ADDENDUM # 001

ST. CLAIR CATHOLIC DISTRICT SCHOOL BOARD
ST. JOHN FISHER CATHOLIC SCHOOL

TENDER NO.: 632-CP1505

Issue Date:
Wednesday May 13, 2015

DETAIL - 4
SCALE = 1:10

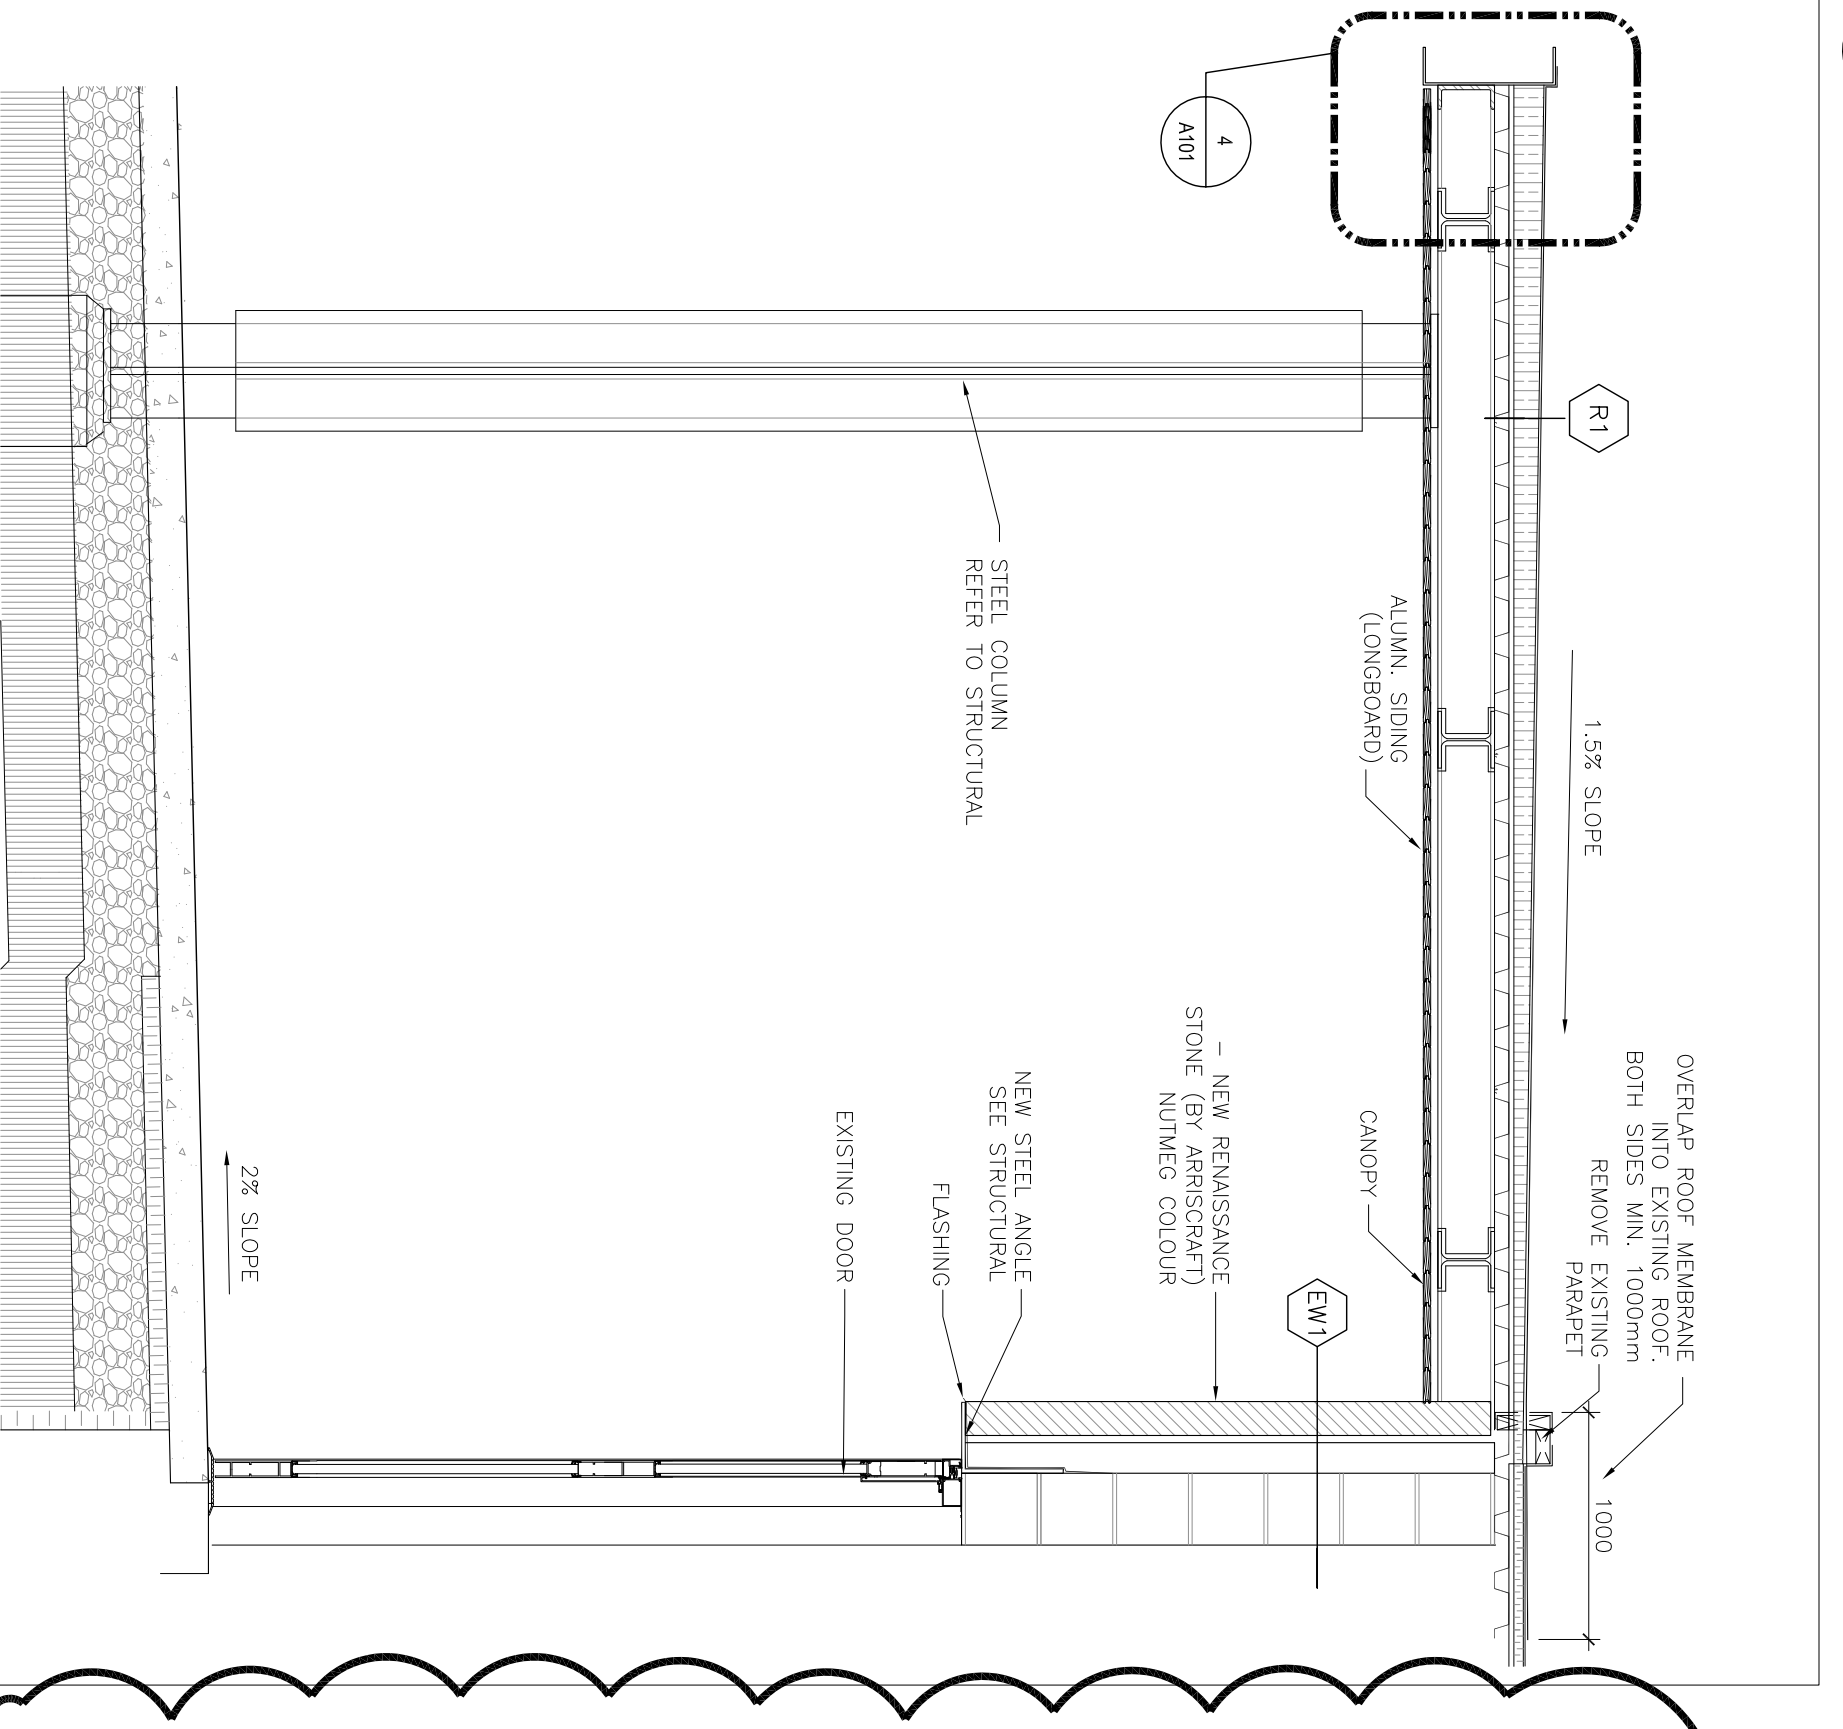
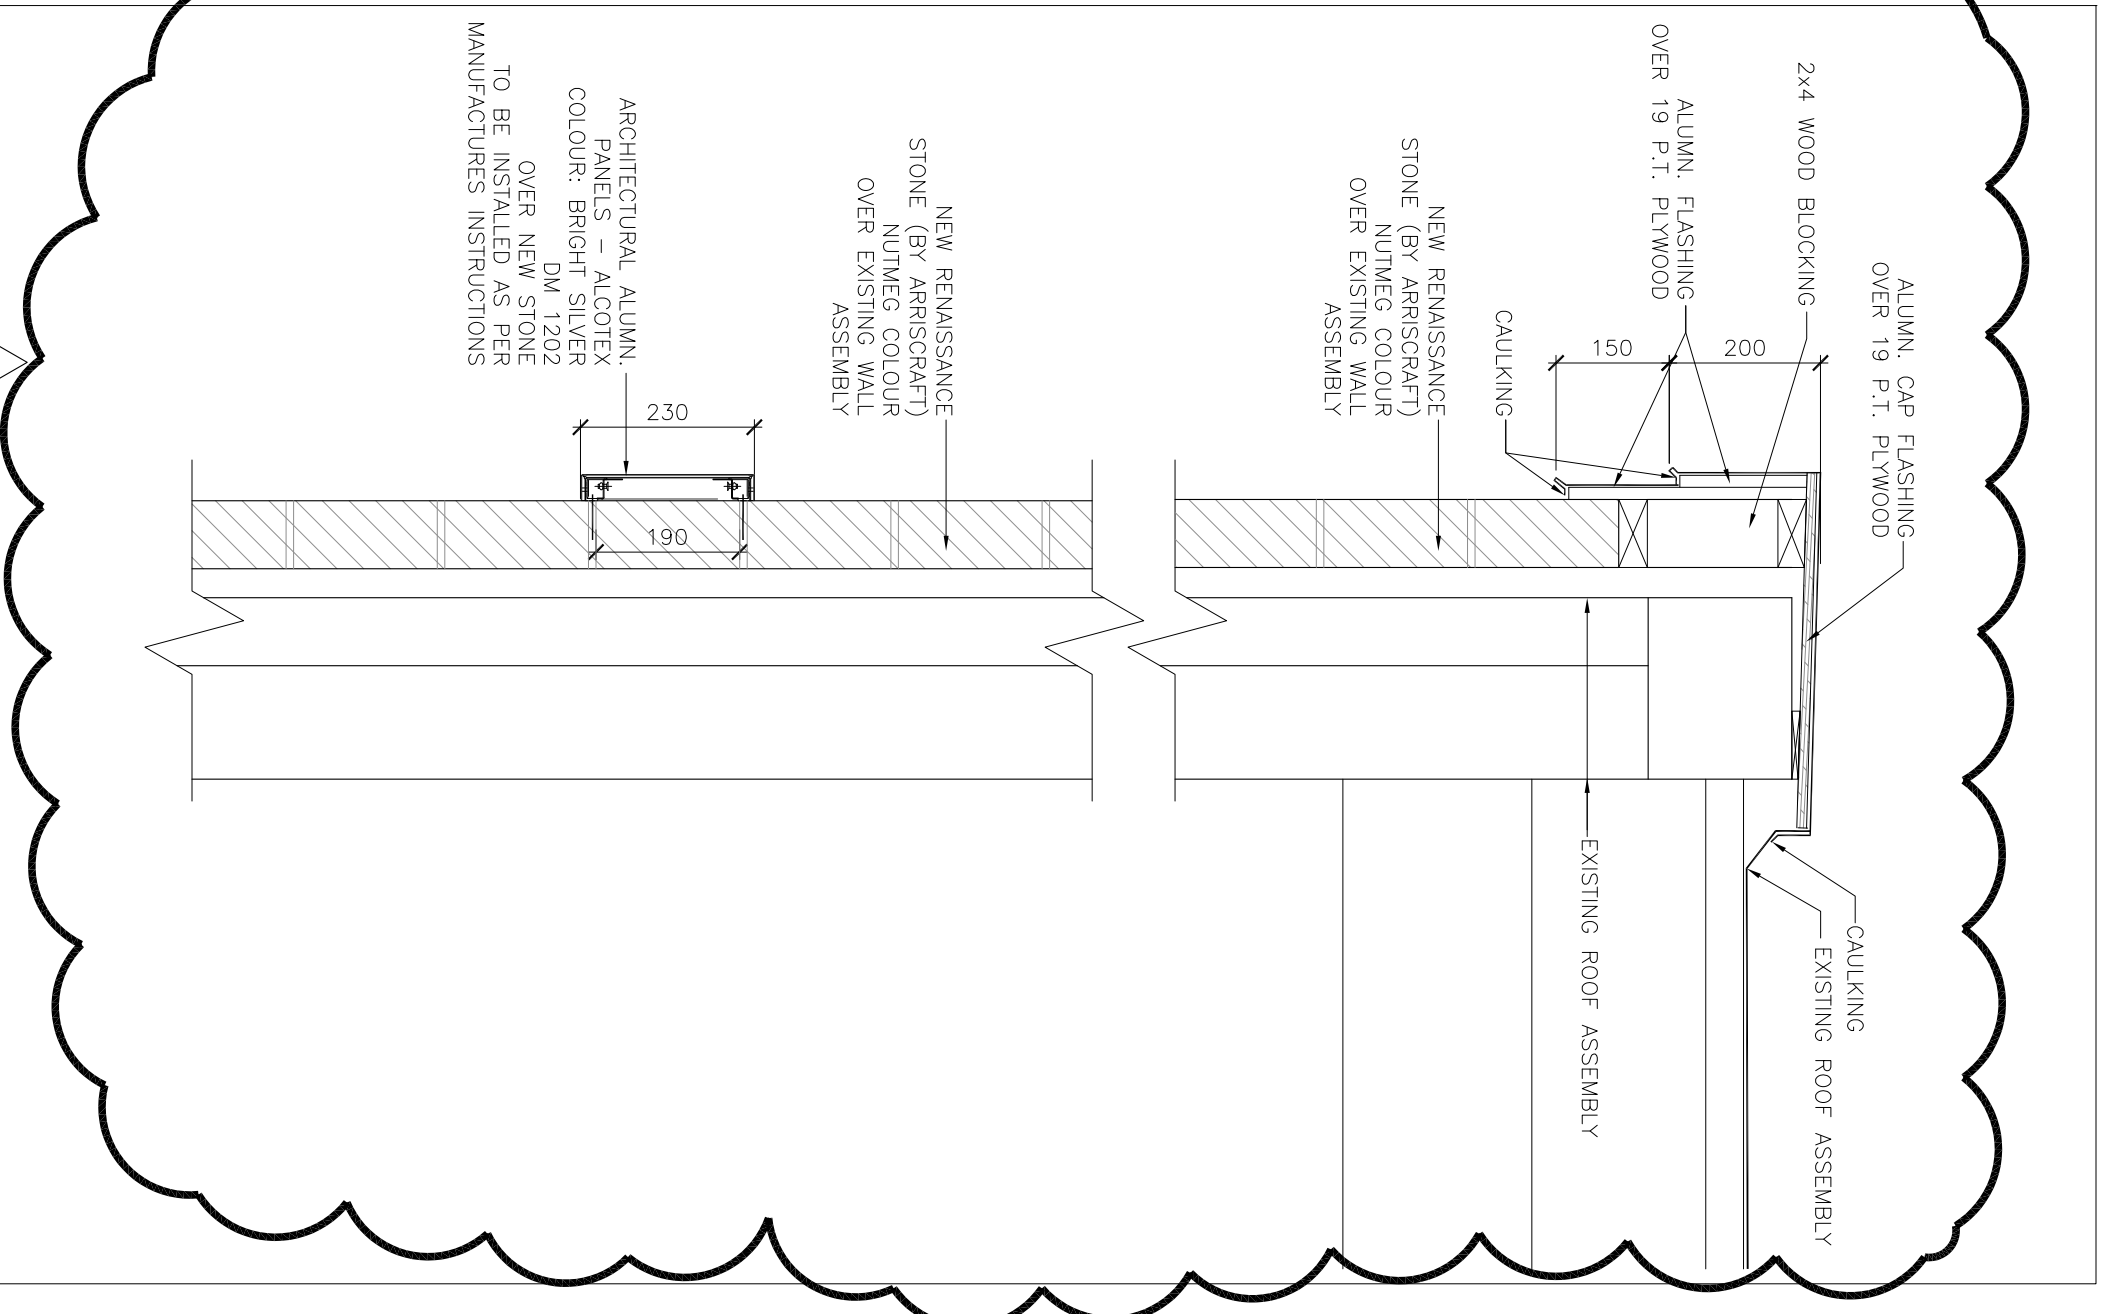
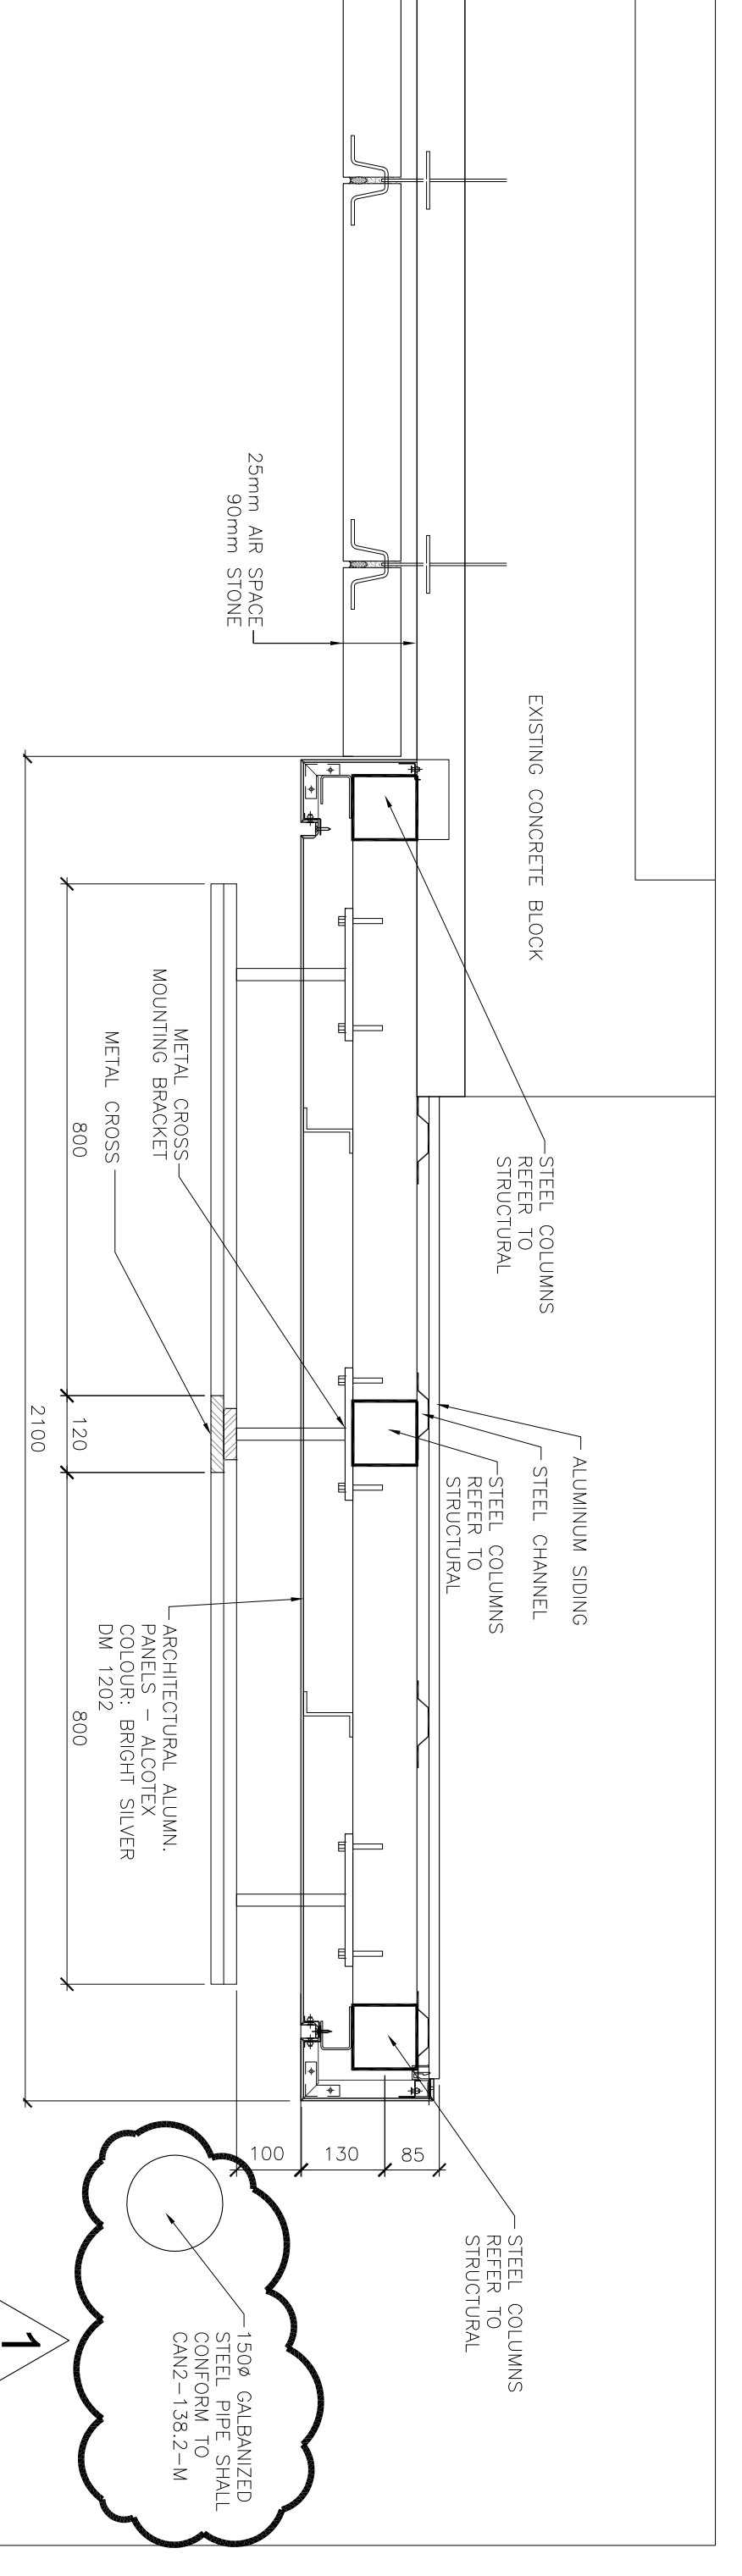
Refer to revision clouds and addendum 1 tags for changes to drawing.

A102 –DEMOLITION PLAN, DEMOLITION NOTES

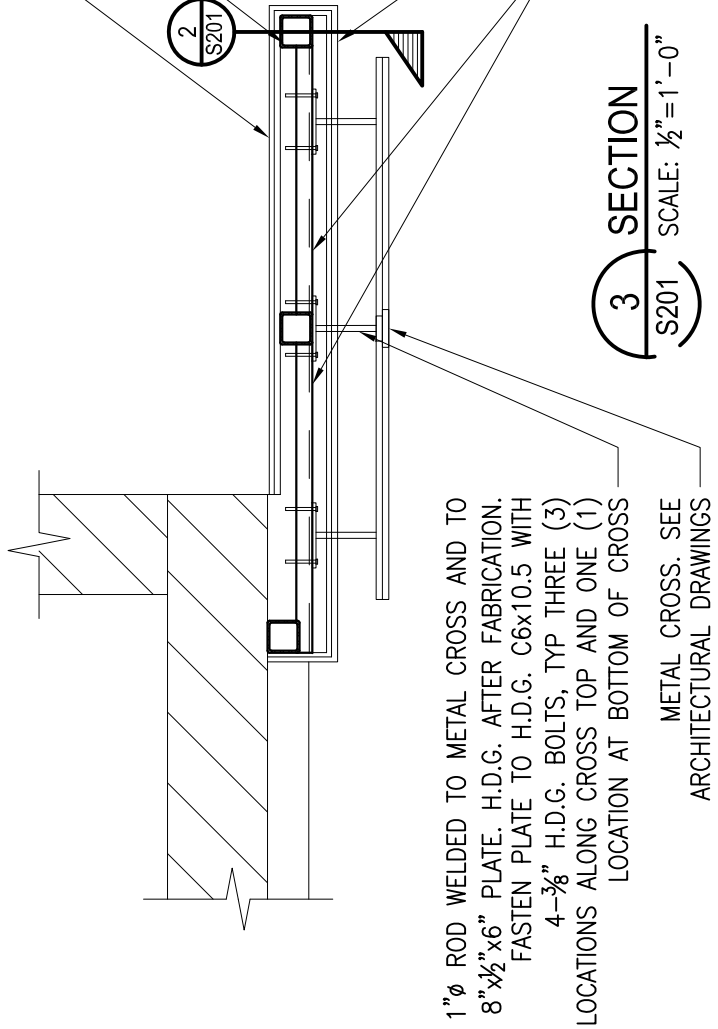
Refer to revision clouds and addendum 1 tags for changes to drawing.
